ADDENDUM #2

Project Name:
Iowa School for the Deaf (ISD)
IDOE ISD Giangreco Hall Water Infiltration Mitigation
DAS# 9455.00
RFB 945500-01
Addendum #2
Dated: November 20, 2025

ROOF PLAN - CENTER & EAST WINGS
1/8" = 1'-0"

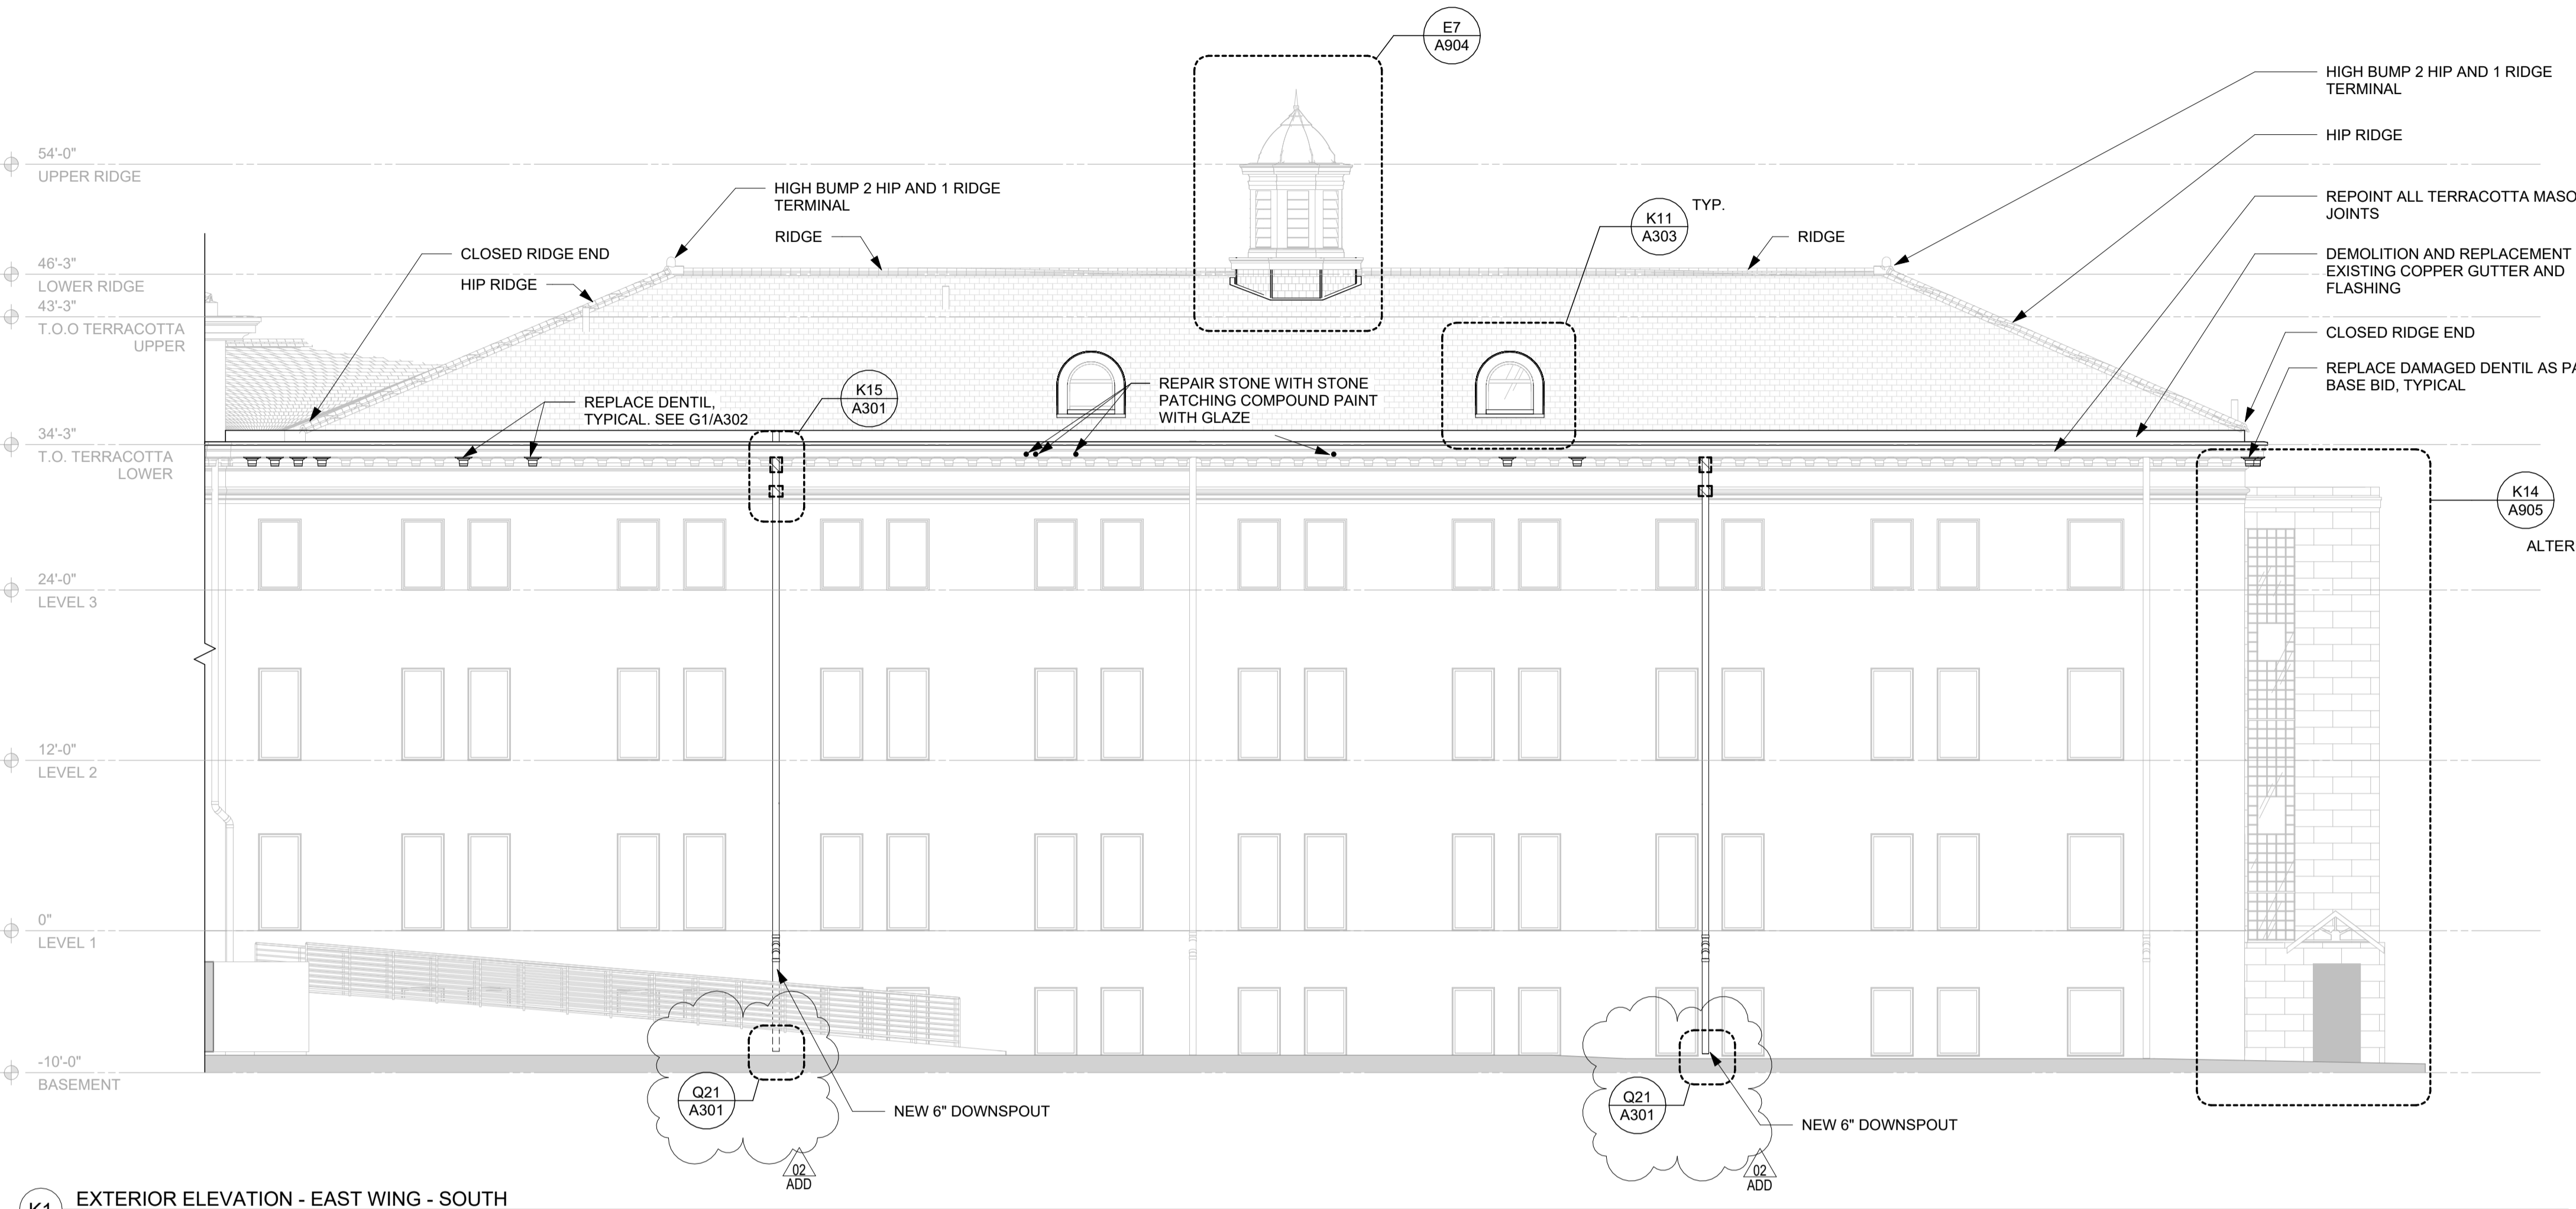
- C. A100 Roof Plan – Center & East Wings
 - 1. A1/A100 - “16 OZ.” copper text deleted from two locations.
- D. A101 Roof Plan – West Wing
 - 1. A1/A101 - “16 OZ.” copper text deleted from one location.

K1 EXTERIOR ELEVATION - EAST WING - SOUTH
1/8" = 1'-0"

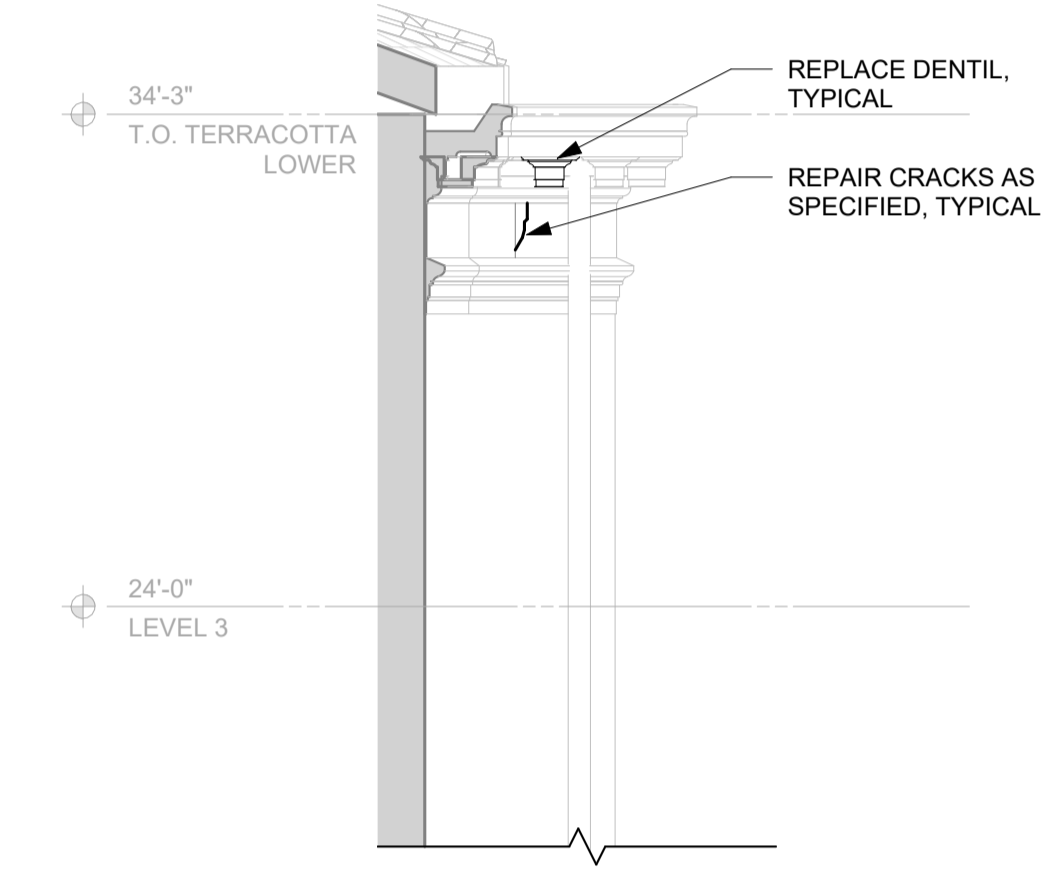
- E. A201 Exterior Elevations – East Wings
 - 1. K1/A201 and A1/A201 – Detail callouts added at base of new downspouts.
- F. A202 Exterior Elevations – Center

K1 EXTERIOR ELEVATION - CENTER WING - SOUTH
1/8" = 1'-0"

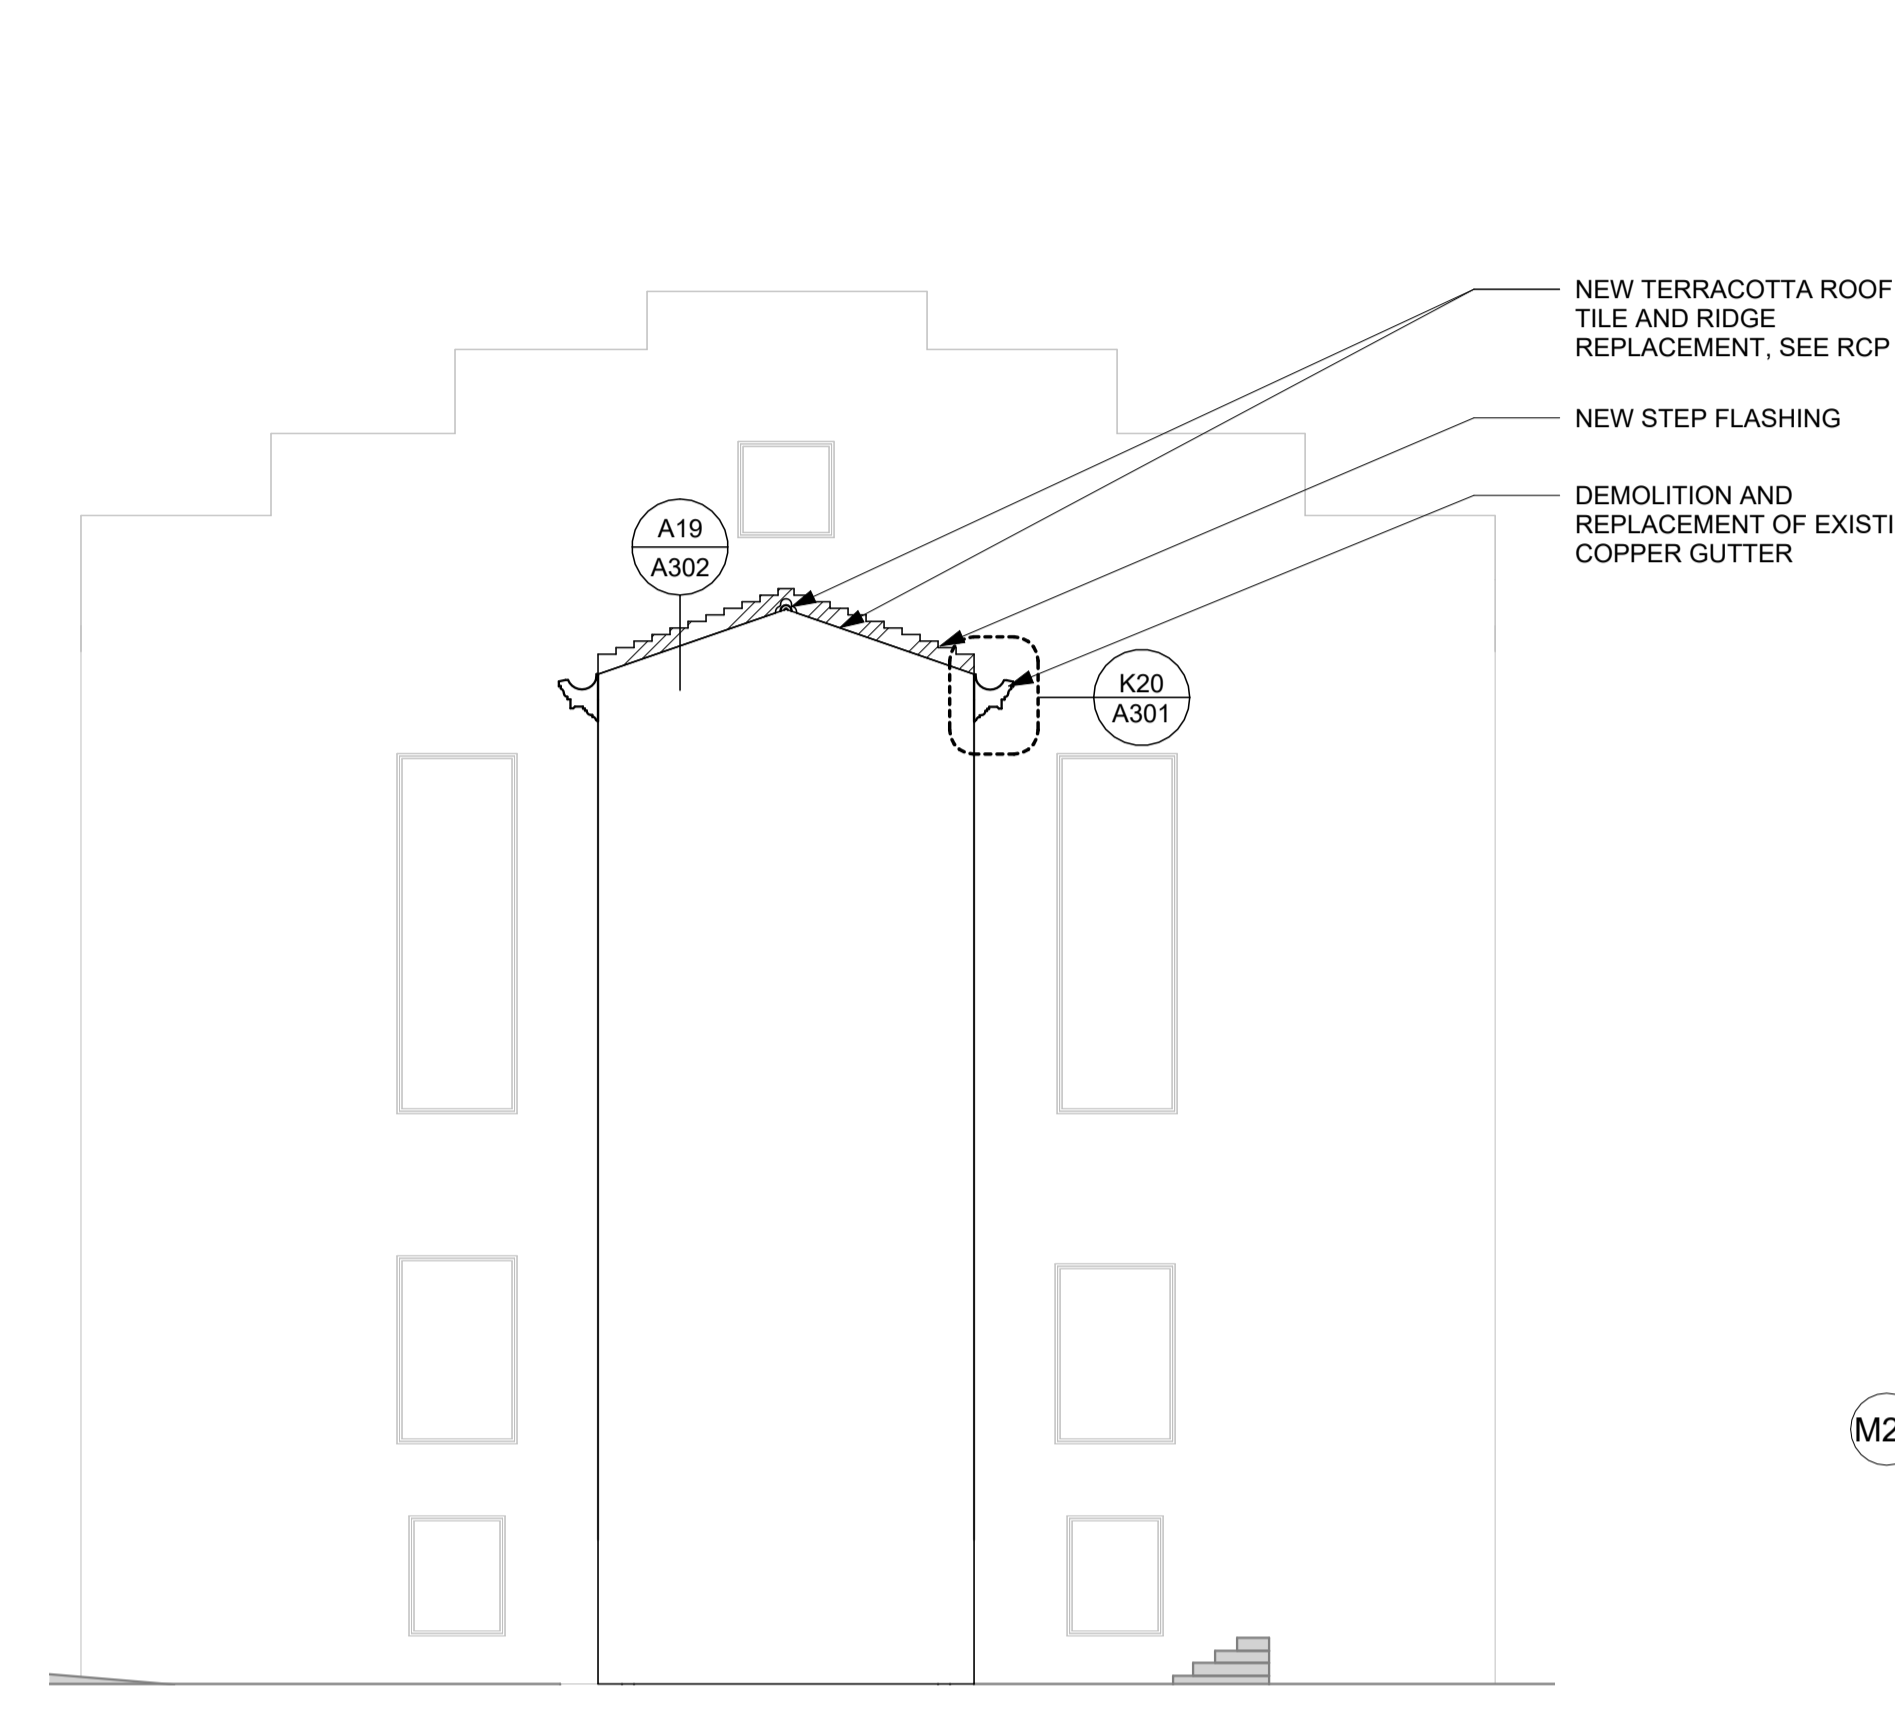
- 1. K1/A202 and A1/A202 – Detail callouts added at base of new downspouts.
- G. A203 Exterior Elevations – West
 - 1. K1/A203 and A1/A203 - Detail callouts added at base of new downspouts.

K17 CORNER DENTIL DAMAGE PHOTO
1" = 1'-0"

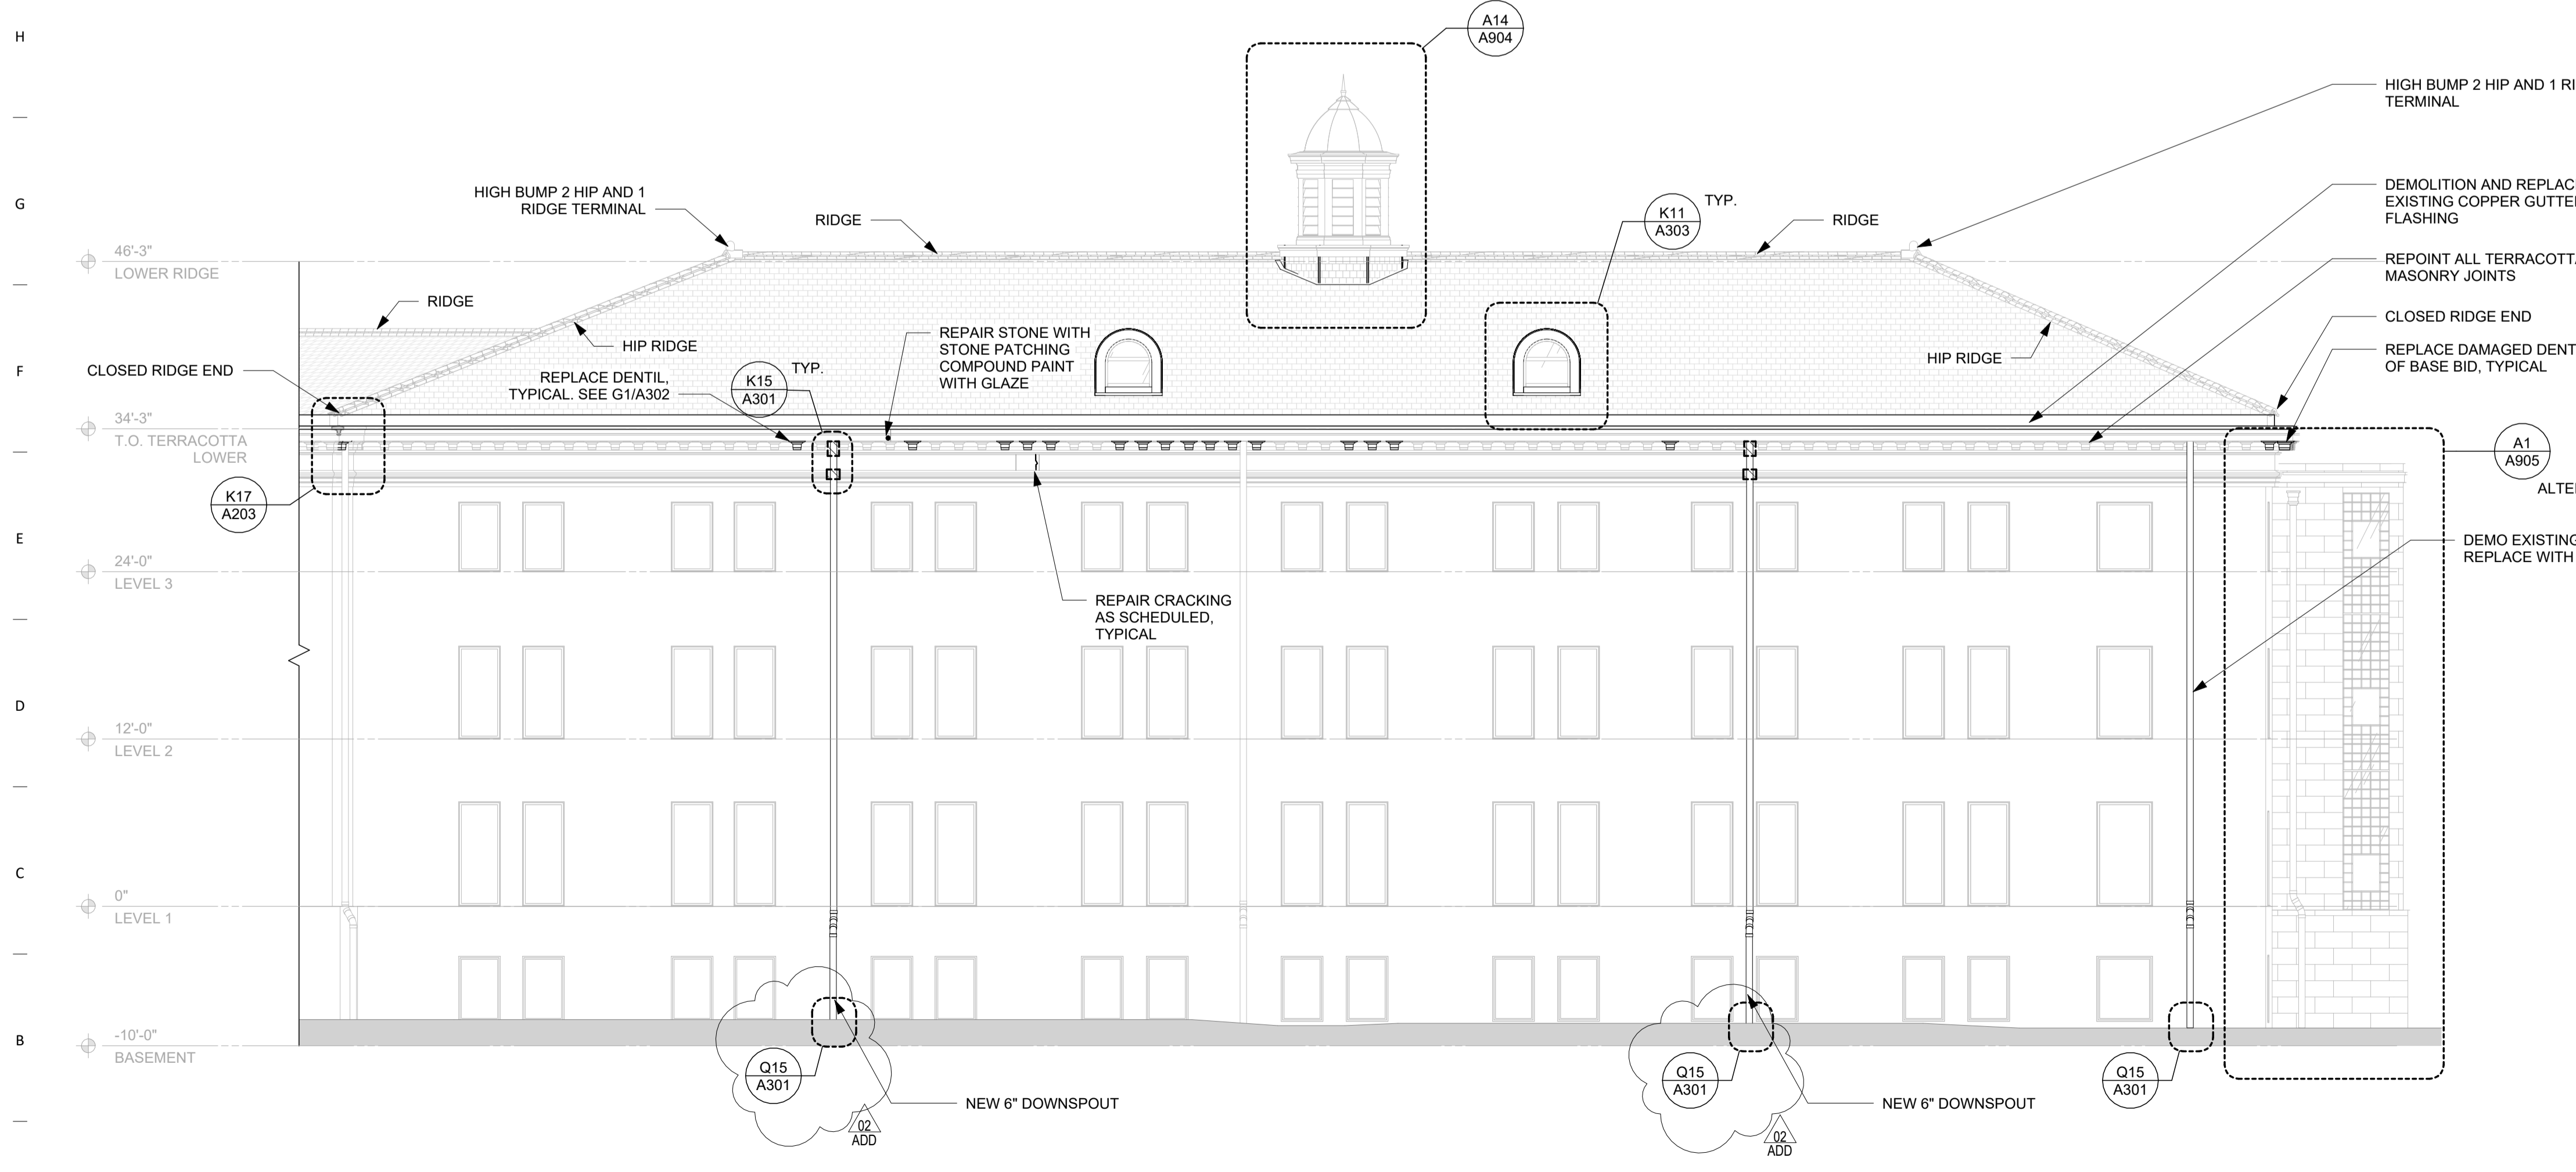
- 2. K17/A203 – Photo added to detail.
